**ZONING BOARD OF ADJUSTMENT
P.O. BOX 227
FREEDOM, NH 03836**

Freedom Zoning Board of Adjustment: **October 26, 2021**

Chairman Lees invited Application # **26-4-21 Eugene W. & Denise Lawnicki**. *Continued from September 28, 2021.*

Submittal to the Freedom Zoning Board of Adjustment Regarding Case 26-4-21, Eugene W. and Denise M. Lawnicki, October 26, 2021 meeting

SPR 8"

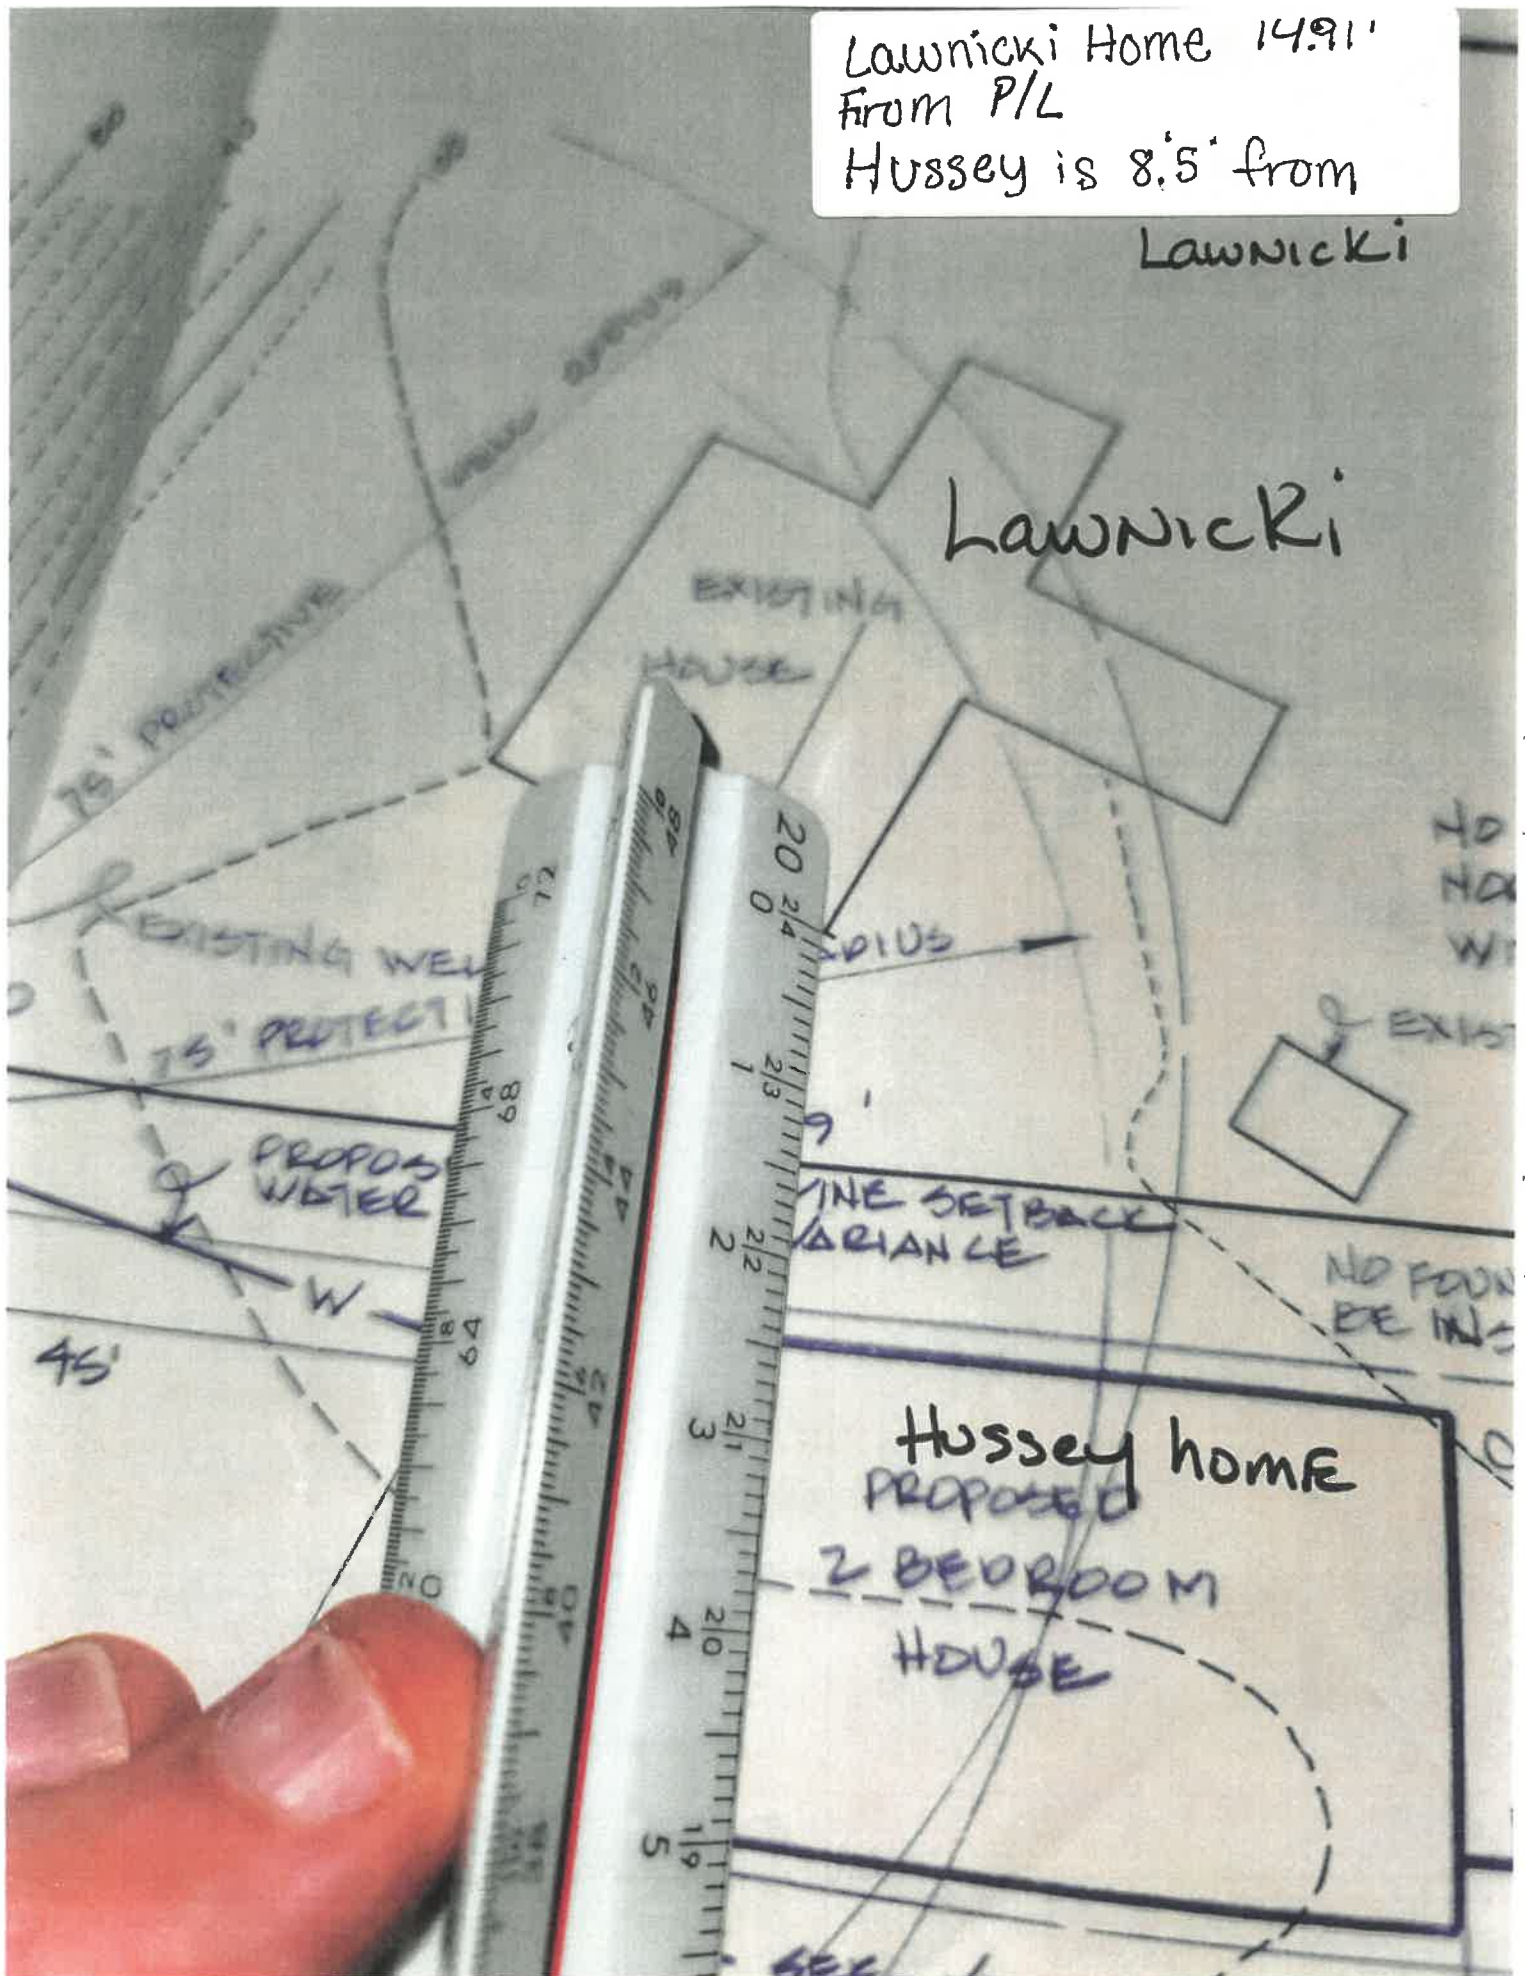
Mark reviewed the handout Primary Viewshed and explained a primary view and homes in the neighborhood located in close proximity to the Lawnicki's property line. The average offset from the neighbors' homes to the Lawnicki's property line is 8.75'. The Lawnicki's home offset to the View property line is 30.93' and to the Hussey property line is 14.91'. Mark stated the Lawnicki's are less non-conforming than the neighbors and suggests that if we go two sides on either side, that is a good betrayal of this neighborhood. Mark continued to review the Viewshed handout which included details around the width of the pathway and the architectural site plan. The proposed additions to the home all meet zoning setbacks. Mark explained the Lawnicki's are not asking for a variance for the porch in front of the garage and breezeway.

Krebs questioned the 20" tree in grid 6 next to the septic system marked for removal and how the 20" pine on the edge of the proposed driveway will survive the construction. He also questioned why the septic tank can't be moved closer to the house to save the 20" pine that they are asking a variance for and move the driveway closer to the Pequawket side to save the 20" tree on the edge of the proposed driveway. Karl stated grid six does not make sense to him because the points don't add up. A brief discussion ensued around grid six. Mark responded to John's question about the driveway and explained he doesn't see that they are putting in a gravel driveway that would need excavation. They were tasked with making sure they had ample room for turnaround which he believes there now is and they will come back if they need to. John responded he is only suggesting moving the turnaround 5' toward Pequawket Trail to avoid 20" pine on the edge of the proposed driveway and help them with the turnaround and maybe a variance would not be needed.

- Grid 2 tree counts are wrong.
- Grid 6 tree counts are wrong.
- The changing room is too big. Whatever the size of the bathhouse was originally is the size going forward. remove the label *bathhouse* on all plans.
- There is a bulkhead on the architectural plan that is not on the proposed plan.
- They are asking for a sideline setback for the house and changing room. May not need a setback for the changing room.
- Paul King stamp the plan.
- Make sure the tree species are correct on the tree cutting plan.
- Existing well labeled.
- Move the septic tank to save the pine.
- Move the driveway to save the other 20" pine.
